Service Information Bulletin

****Advanced Notice of Recall 07V-466****

Subject: Air induction into brake system

Model: K 1200 R Sport (K43HV)

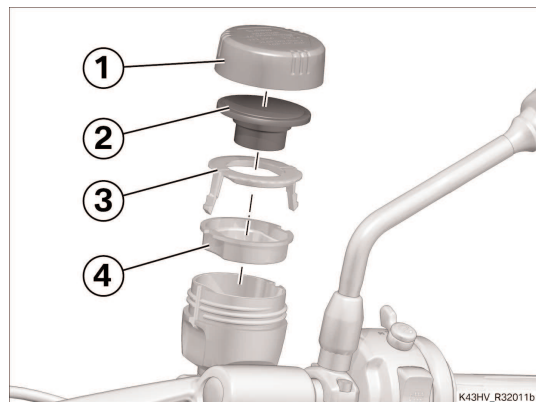
Details: Vibration on a long ride at constant high engine rpm can, under certain circumstances, cause foaming of the brake fluid in the brake-fluid reservoir of the front brakes. The possibility of this foaming causing air to enter the brake system must be considered.
The braking efficiency of the front brakes can diminish severely, depending on the volume of air that enters the brake system in this way.

Aftersales Solution: The front brakes of the motorcycles affected by this problem have to be bled and a damper weight (2) has to be installed in the brake-fluid reservoir of the front brake system. The purpose of this weight is to damp the vibrations that can cause the brake fluid to foam. The black cap of the reservoir must be removed and a gray cap (1) substituted instead.
In addition, for visual reasons the black cap of the clutch-fluid reservoir must also be removed and a gray cap substituted.

- 1=Cap (gray)
- 2=Damper weight
- 3=Lock Washer
- 4=Diaphragm
